T100 and Q155 medium pressure diaphragm upgrade and secondary containment system.

The T100 & Q155 Medium Pressure diaphragms and hydraulic components have been upgraded to greatly improve reliability of the pump. The upgrade makes numerous improvements to the pump including:

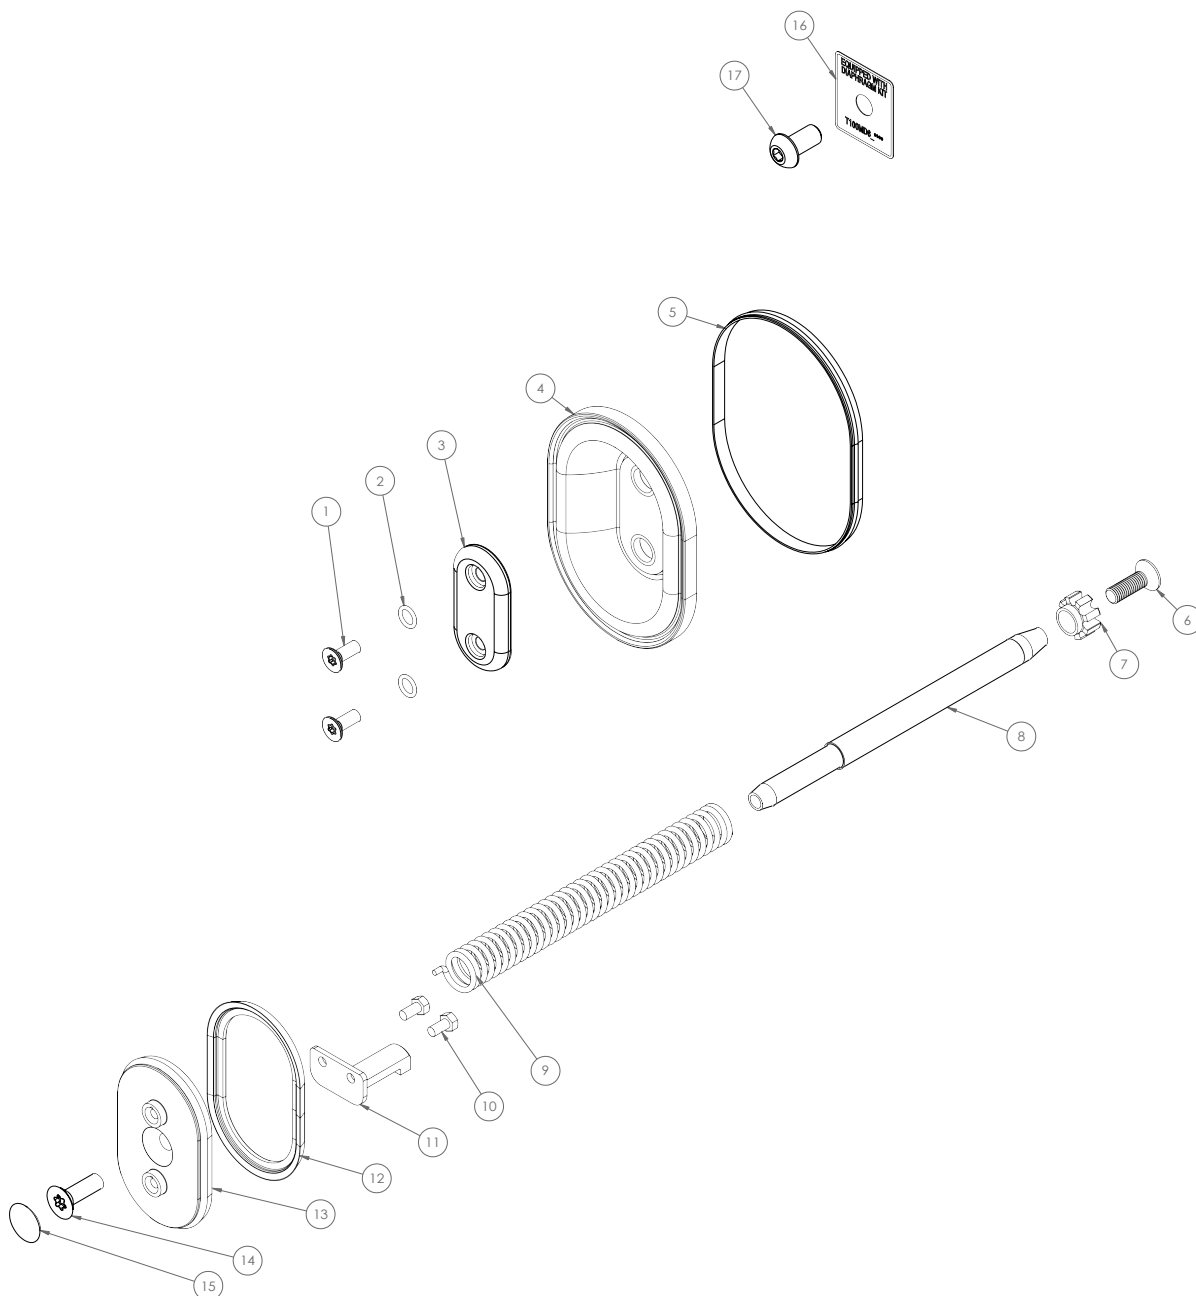
- Improved diaphragm sealing under high suction pressure conditions, including for stationary pumps under high suction pressures.
- Addition of the secondary containment system that prevents excess process fluid loss in the event of a diaphragm failure by isolating the hydraulic end from the fluid end under high suction pressure conditions.

The new diaphragm is only compatible with the new hydraulic components, so customers performing a diaphragm upgrade change will need to upgrade their hydraulic components at the same time. For ordering convenience, Wanner has created an upgrade kit that contains all the components needed for a full upgrade. The part number of the Upgrade Kit is 177-919, 177-920 & 209-919, 209-920.

10. Place the diaphragm (4) into the diaphragm plate with the back-up ring (5). Make sure screw head plug is in place when inserting diaphragm.
11. Place two O-rings (2) into the follower (3).

12. Place the follower into the diaphragm (4).
13. Tighten the follower to the diaphragm clamp using two follower screws (1). Apply Loctite and tighten to 80 in.-lbs. (9 N-m).
